Downtown Smart Growth District (DSGD) Plan Review
M.G.L. Chapter 40R
DECISION

Project: 459 Main Street
Applicant: GC Fodera Contracting, Inc.

Downtown Smart Growth District (DSGD) Plan Review
M.G.L. Chapter 40R
DECISION

FIGURE 5.B

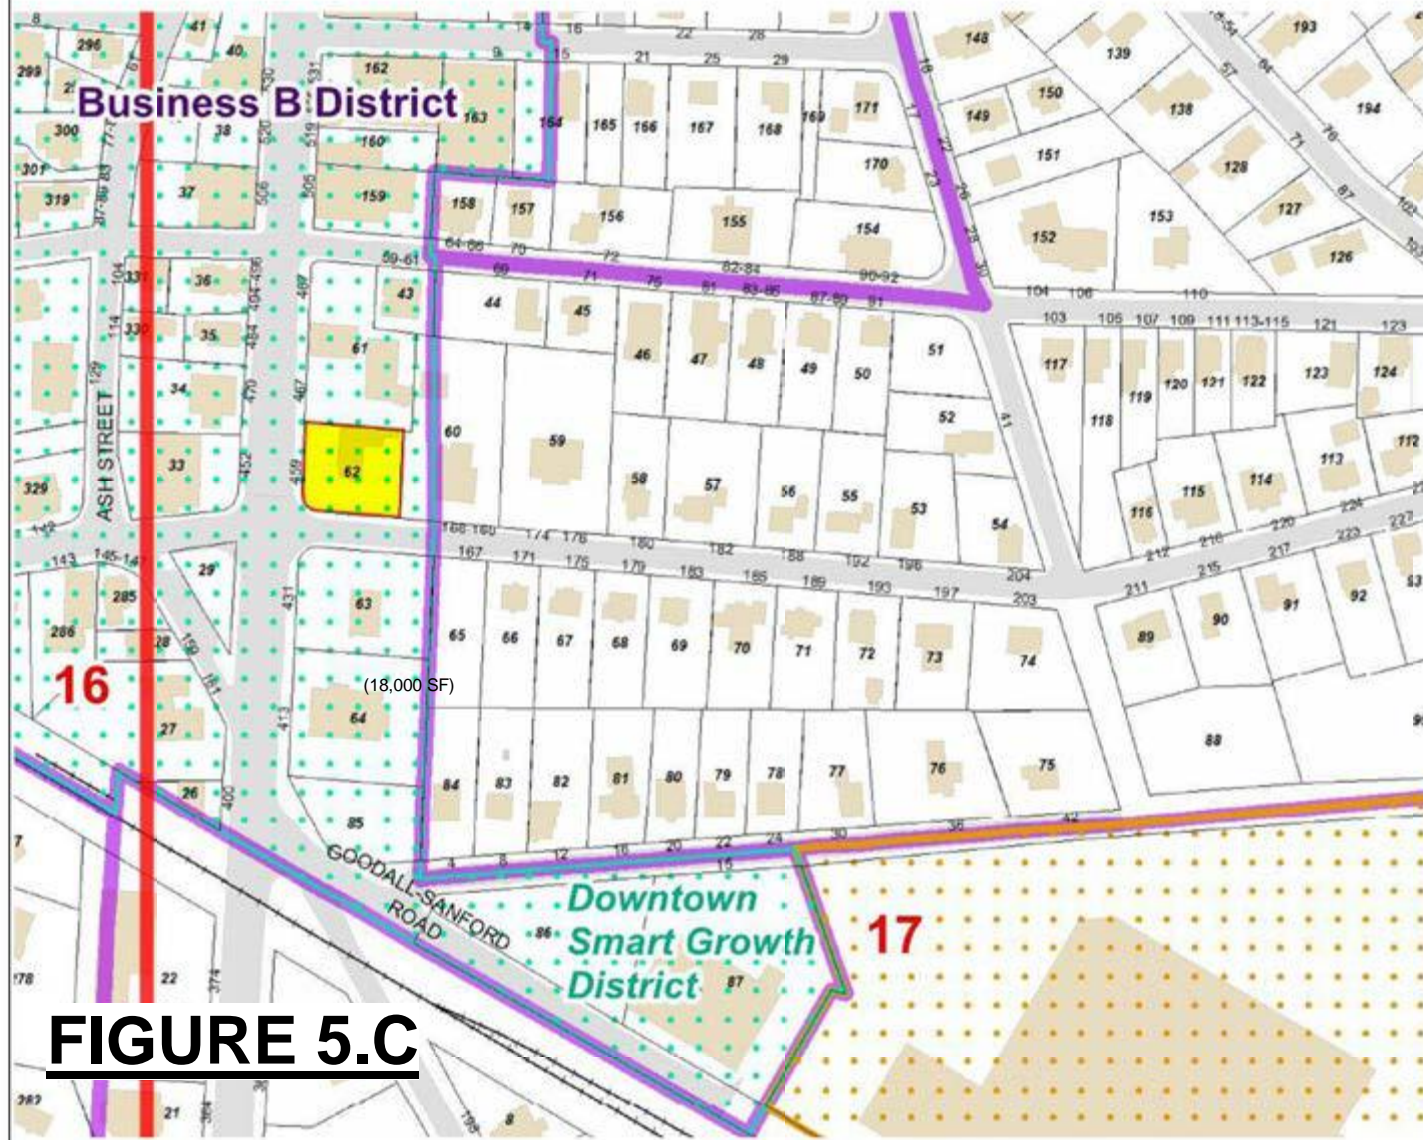
Comment: Please correct FAR calculation on page G002 Figure 5.B to 2.72 (includes required parking areas)

Response: This calculation of FAR was made in accordance with Section 2 of the Reading Zoning Bylaw and reflects the fact that the parking area is not enclosed by "exterior walls", and therefore is excluded under the definition of net floor area (as well as gross floor area, since it is non-habitable space). If, notwithstanding, it is preferred to interpret the parking area as constituting net floor area, the total would be 2.72. See sheet G002.
